VALIDATION OPINION FOR REVISION OF REGISTERED MONITORING PLAN

**Guangrun Hydropower Project in
Hubei Province, P.R. China**

UNFCCC Ref. No. 0904

Figure 1 Line diagram of the electrical wiring system of the project

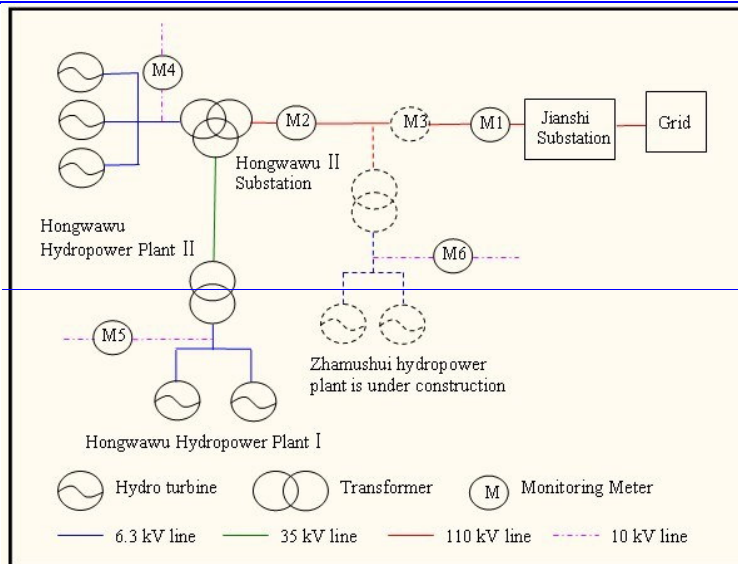
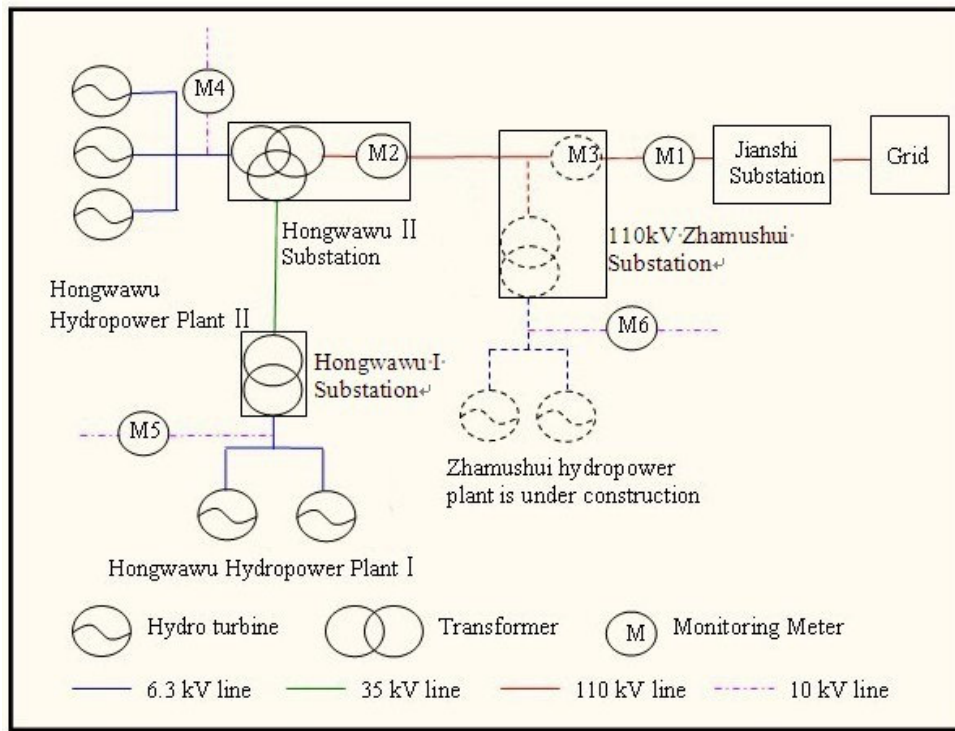
3. In the revised monitoring plan, the electrical wiring system has been detailed according to the actual situation. The project consists of three small-sized hydropower plants (Hongwawu I, Hongwawu II and Zhamushui hydropower plant). Hongwawu II hydropower plant directly connects to [110kV](#) Zhamushui substation through 110kV transmission line, while Hongwawu I hydropower plant connects to Zhamushui substation through Hongwawu II substation, the transmission line between Hongwawu I station and Hongwawu II station is 35kV transmission line. [110kV](#) Zhamushui substation then connects to 110kV Jianshi Substation of the grid through 110kV transmission line. Please refer to the following line diagram of the electrical wiring system of the project.

The electrical wiring system in the revised monitoring plan was verified to be in compliance with the actual implementation (/11/) but deviates from the description in the registered PDD. On page 5 of the registered

PDD section A.4.3, it was described that “Hongwawu hydropower plant includes two powerhouses (powerhouse I in 8MW and Powerhouse II in 10MW) and a 4.6 km long 35 kV transmission line to Zhamushui substation” whereas the transmission line is 110kV transmission line which had been verified during site visit.

On page 154-155 of the Feasibility Study Report (FSR, /12/) dated August 2005 which has been validated by the validator, two plans (Proposal A: an onsite 6.3/35kV substation at Hongwawu II and 35kV transmission line to Zhamushui substation where a 35/110 kV substation will increase the voltage to be 110kv; and Proposal B: an onsite 110kV substation at Hongwawu II which will be connected to Zhamushui substation through 110kV transmission line) were proposed for the electrical wiring system between Hongwawu II substation and Zhamushui substation. 110kV transmission line of Proposal B was chosen by the project company due to its much lower line loss.

Via document review of the FSR, registered PDD, IRR spreadsheet (/13/) which has been validated by the validator, it is confirmed by the assessment team that the investment decision was made on the basis of proposal B, the same was applied in the IRR spreadsheet. It is sufficient to conclude that the description of the 35kV transmission line to Zhamushui substation (Proposal A) in PDD section A.4.3 was actually wrongly quoted by PP when finalizing the PDD at validation stage. Considering the description of 35kV transmission line to Zhamushui substation under registered PDD section A.4.3 was just a typo, it is assessment team's opinion that the project activity has been implemented and operated as per the project design.

The detailed electrical wiring system in the revised monitoring plan is only to make a clear presentation of the monitoring system and is not deemed to be a change to the monitoring system.
